JOHN AND DEBRA WILLIAMS
SUBDIVISION
In Sedgwick County, Kansas

FINAL PLAT

Re: S/D 96-52 - JOHN AND DEBRA WILLIAMS ADDITION (Final Plat)

**CASE NUMBER:** S/D 96-52 JOHN AND DEBRA WILLIAMS ADDITION

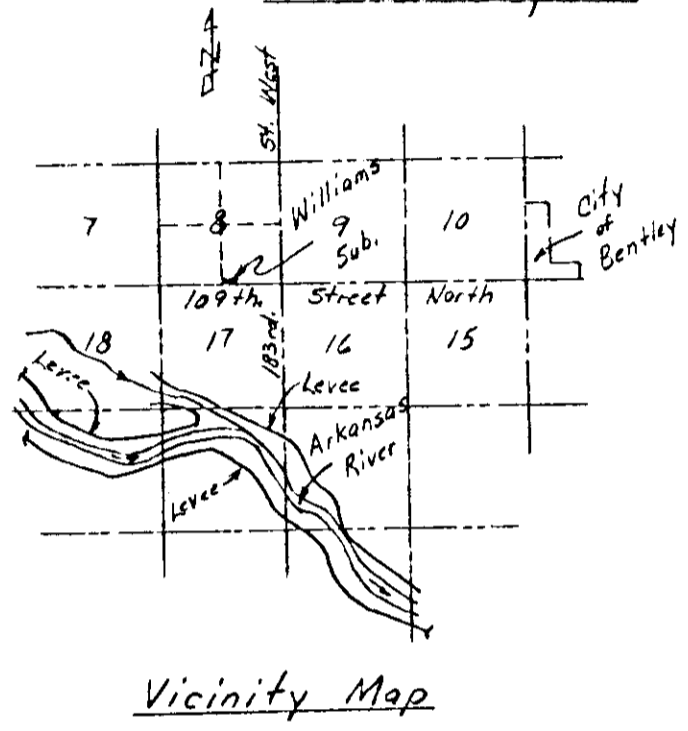
Handwritten notes: Floodway long, Min. Plat - Clearly Note K.O. (K.O. deleted) do not on solid, Delete .294 sq row, AC

- ~~D.~~ On the final plat tracing, the face of the plat shall clearly label the area of street dedication and this area shall be shown in a more specific manner from the adjoining lot. Dashed lines, fainter lines, etc. should be used for the 20-foot dedication so as to make it distinctly separate from the adjoining lot. The .29 Acre noted in the area of dedication shall also be deleted.

- ~~E.~~ The final plat tracing shall indicate a 30-foot building setback to 109th Street North.
- ~~F.~~ The face of the plat shall also note the dedication of the access control as stated in the platlor's text.

- G. On the final plat tracing, a tie point shall also be shown on the face of the plat.
- H. The final plat tracing shall indicate a minimum building pad elevation as required by County Engineering. Both the plat's text and face of the plat shall note such an elevation. Also, both an on-site and off-site benchmark shall be shown.

- P. Prior to the plat tracing being released for County Commission scheduling, the applicant shall have submitted to County Engineering a drainage plan and such drainage plan shall have been approved. The final plat tracing shall also accurately depict the boundary of the floodway reserve. Before or with the submittal of the plat tracing to Planning, the applicant shall provide a letter from County Engineering indicating the satisfaction of these requirements.
